**ASCE-INDOT  
STRUCTURAL SUBCOMMITTEE  
MEETING NO. 58 MINUTES  
March 15, 2013**

**From:** Phillips, Elizabeth  
**Sent:** Wednesday, February 20, 2013 4:45 PM  
**To:** McCool, Mike  
**Subject:** FW: Proposed Spec Change - Stay in Place Deck Forms

Figure 404-2B

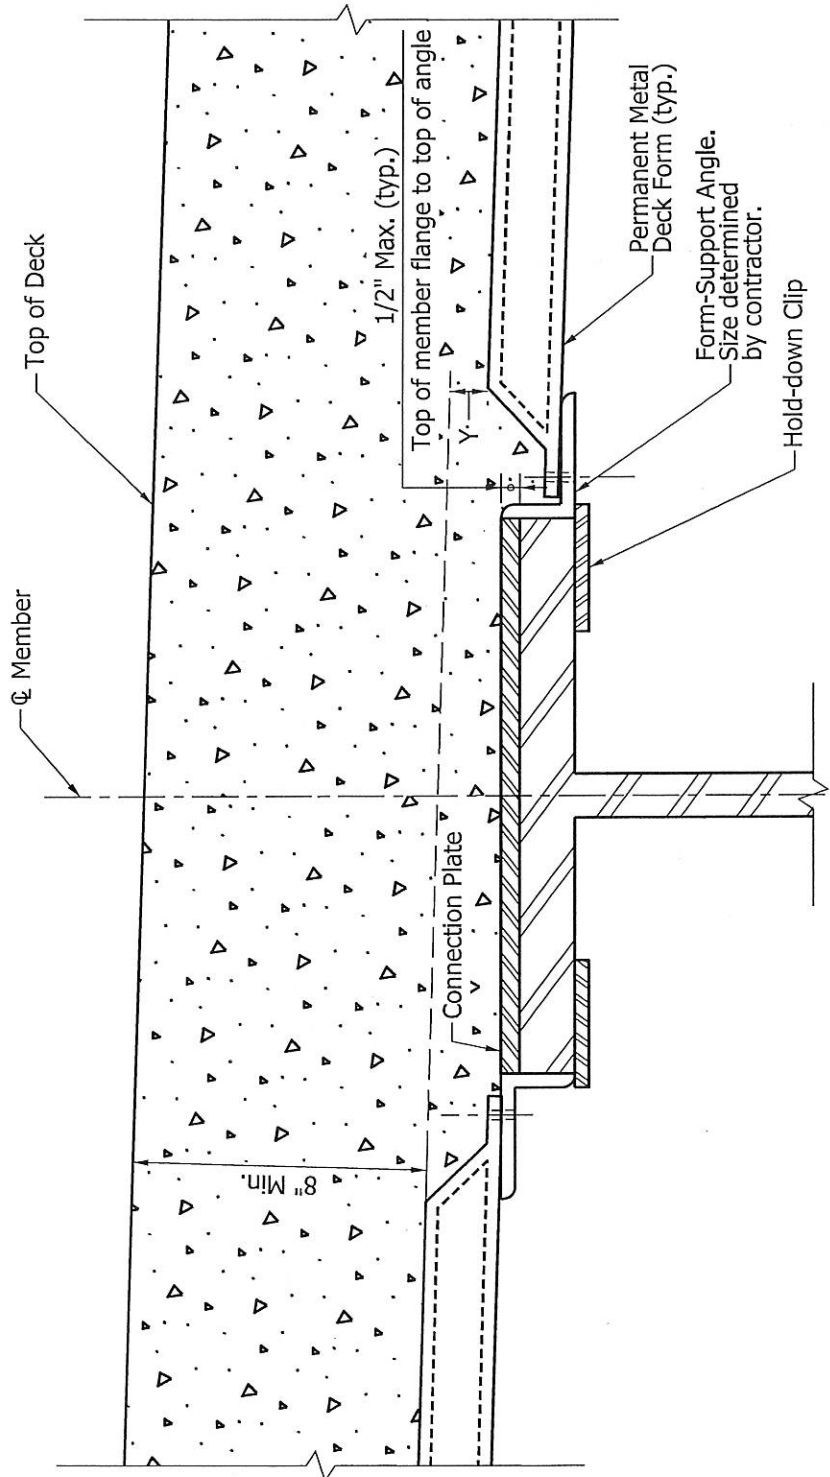
Limiting the projection of the support angle to ½" is on the Standards Committee agenda for tomorrow. Below is some feedback I got today from the construction industry. I'm not seeing the issue as we already require a minimum ¾" fillet on the low side. Would you help me with some explanation to alleviate their concerns or explain to me why this is a bigger issue than I thought.

There is considerable industry concern about the proposal to limit the projection of the form support (angle) to ½-inch above the top flange. Contractors see that this would create delays and add considerable costs to projects. There is also concern that this could result in thicker decks, increasing the dead load of the structure.

Until the distance between the top of the beam and the finish grade of the deck is determined, the installer and supplier may not be able to determine the angle sizes. The installer may wait until fillet depths are established to order the support angles. I'm told this could take 4-6 weeks. A tolerance of only ½-inch does not allow for much tolerance if the top of the beams are not consistent.

Contractors see that they would have to either cut the angle (form support) after placement to grade or set to the half-inch and place a thicker deck.

9. Stay-in-place metal form attachment requirements were pulled from the Standards Committee due to industry comments. Elizabeth Phillips will reintroduce the changes clarifying that this only affects angle connections in the "L" position.

Figure 8-405.08A

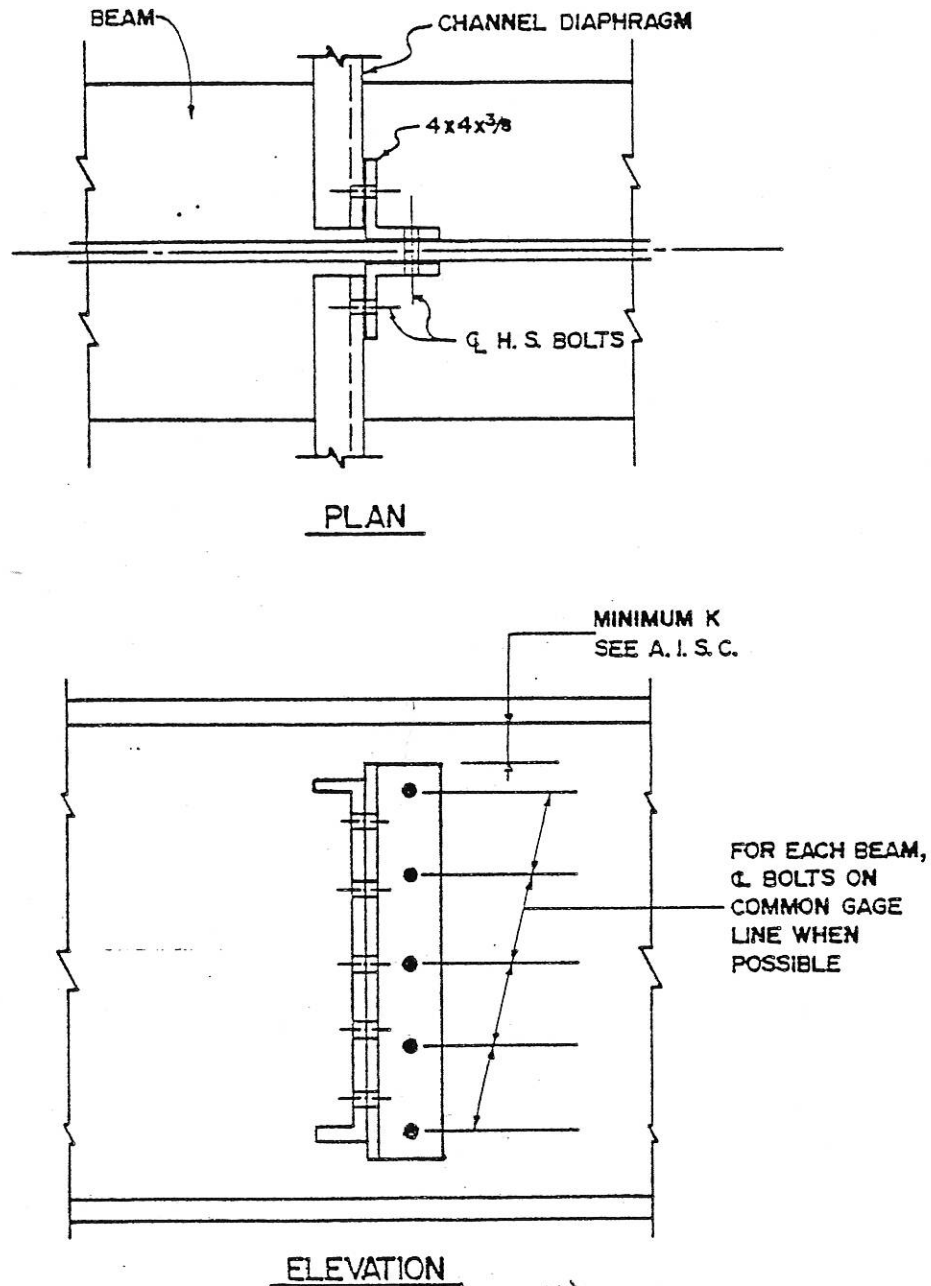
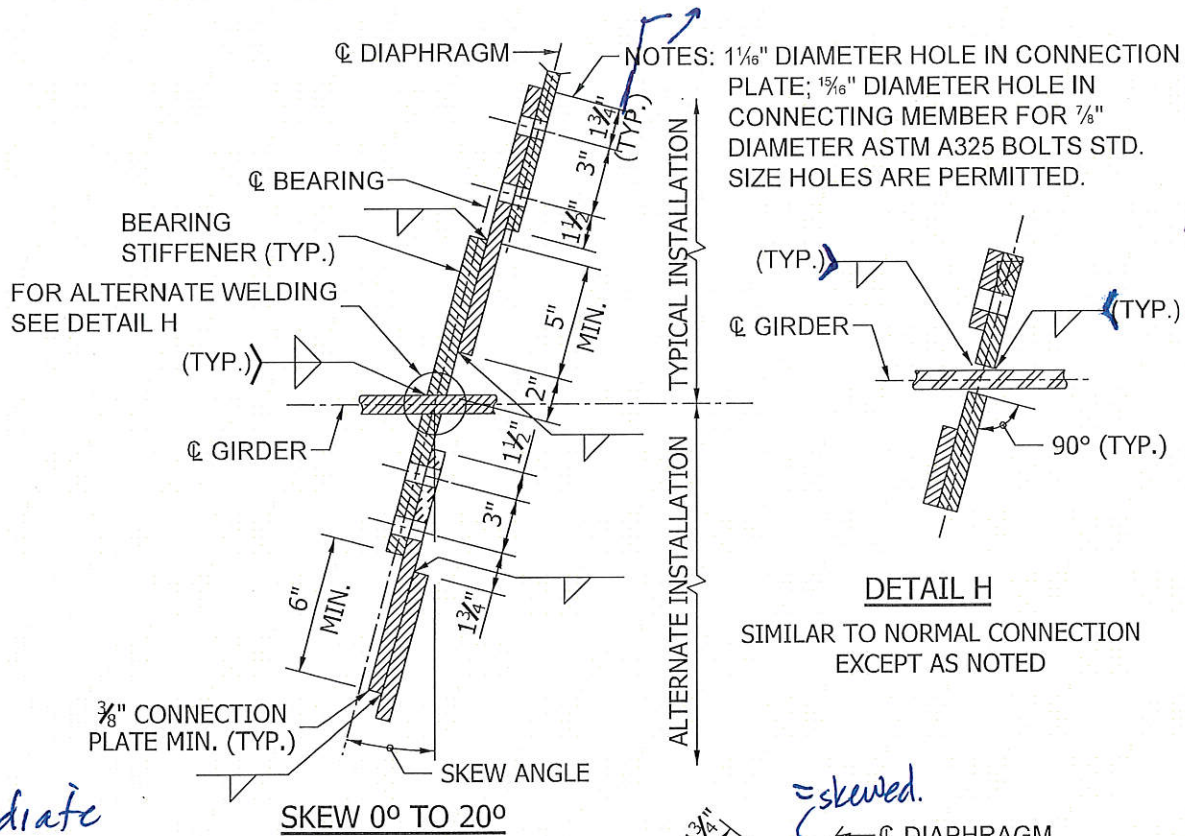
10. Steel Diaphragm details need to be updated to include Hybrid Girders. Elizabeth Phillips will provide details for review at the next meeting.
11. Steel Diaphragm details need to be updated for rolled beam sections. The 2012 AASHTO allows less than full width bolted connections for rolled beams. Mike McCool will develop details and have them reviewed by Burleigh Law and Mahmoud Hailat. This will reintroduce Fig. 8-405.08A from the old Design Manual.

Figure 407-5H

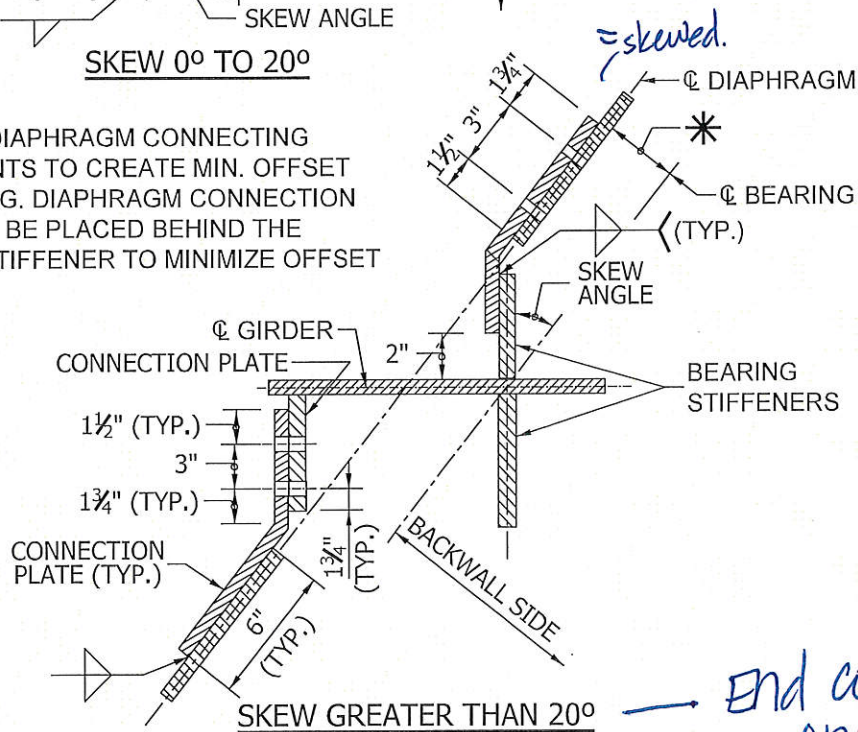
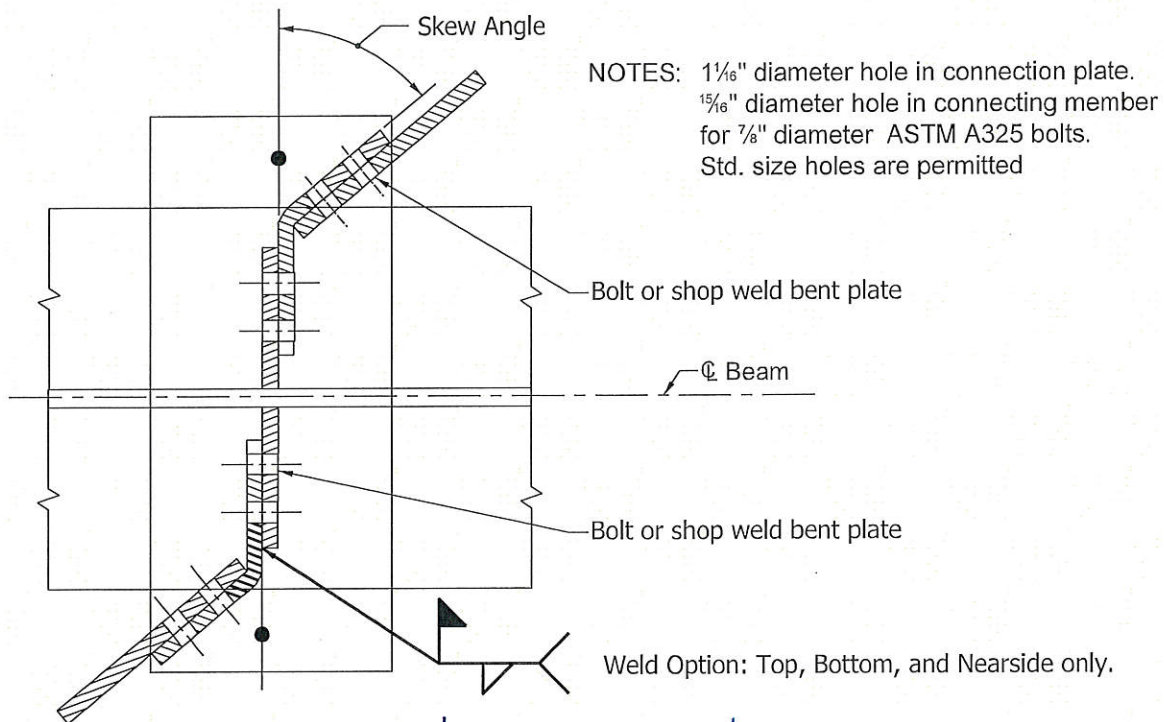
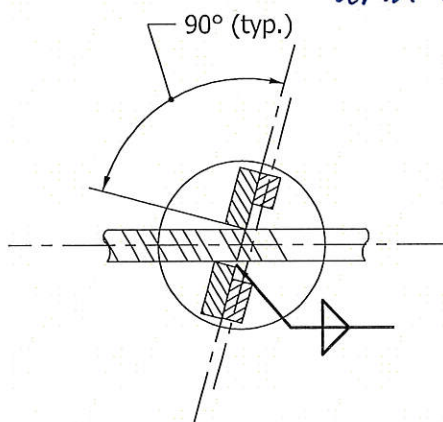
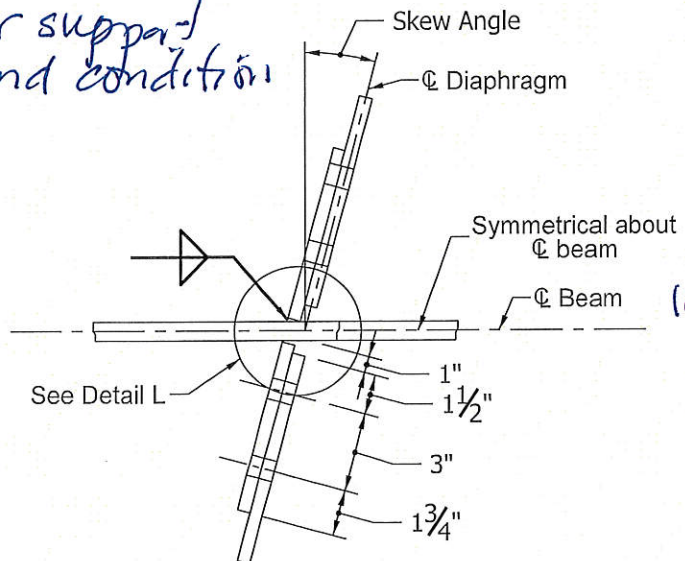
12. Stainless steel beveled plates should be used for elastomeric bearings under joints. All other locations may be galvanized.
13. Connection Plate Details – Elizabeth brought suggested details changes that agree with IDM 407-503.1 text. She will send markups to the committee so they can review and comment. Elizabeth will then present revised details and ext at the next meeting for approval.
